UNITED STATES PATENT AND TRADEMARK OFFICE

APPLICATION NO.	FILING DATE	FIRST NAMED INVENTOR	ATTORNEY DOCKET NO.	CONFIRMATION NO.
10/718,514	11/24/2003	Kenneth Gordon Walker	W245 0004	1974
720	7590	08/25/2005	EXAMINER	
OYEN, WIGGS, GREEN & MUTALA LLP 480 - THE STATION 601 WEST CORDOVA STREET VANCOUVER, BC V6B 1G1 CANADA			BOGART, MICHAEL G	
			ART UNIT	PAPER NUMBER
			3761

Office Action Summary

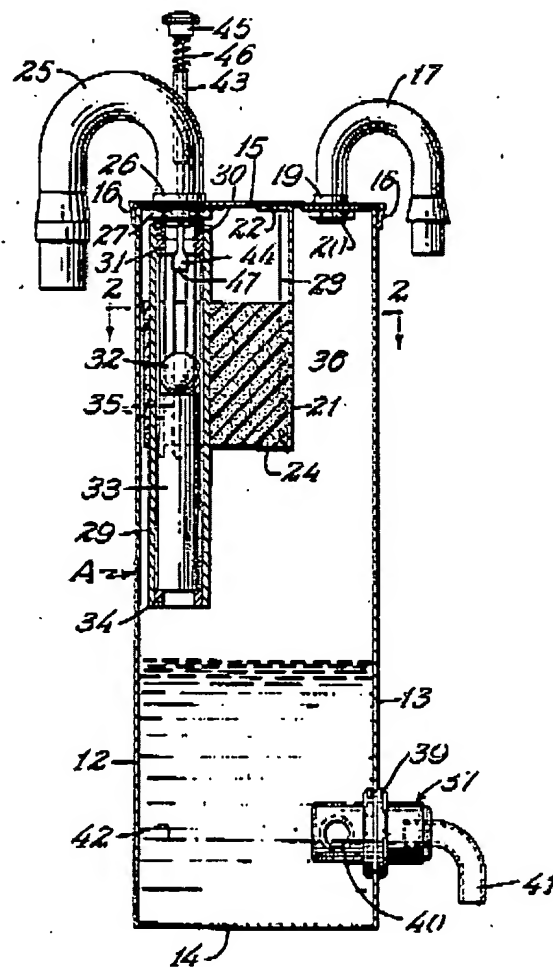
Claims 1 and 2 are rejected under 35 U.S.C. § 102(b) as being anticipated by Beguiristain (US 3,612,089).

Regarding claim 1, Beguiristain teaches a check valve (29, 31, 32) for a canister (12, 13, 14, 15) adapted to receive fluids, said canister (12, 13, 14, 15) adapted to receive

fluids, said canister (12, 13, 14, 15) having a vacuum port (25, 29) for application of vacuum to said canister (12, 13, 14, 15) for inducing a flow of fluids into said canister (12, 13, 14, 15), said check valve (29, 31, 32) being operably coupled to said vacuum port (25, 29) for stopping said application of vacuum to said canister (12, 13, 14, 15) when said fluids in said canister (12, 13, 14, 15) reach a pre-determined level (see figure 1, below).

Regarding claim 2, Beguiristain teaches a check valve (29, 31, 32) which comprises:

- (a) a floatball (32) operably coupled to a needle valve (44); and

(b) a floatball cage (29, 31) for housing said floatball (32), said floatball cage (29, 31) comprises a needle valve guide (27, 29, 43) for slidably retaining said needle valve (44)(col. 2, lines 26-75)(figure 1).
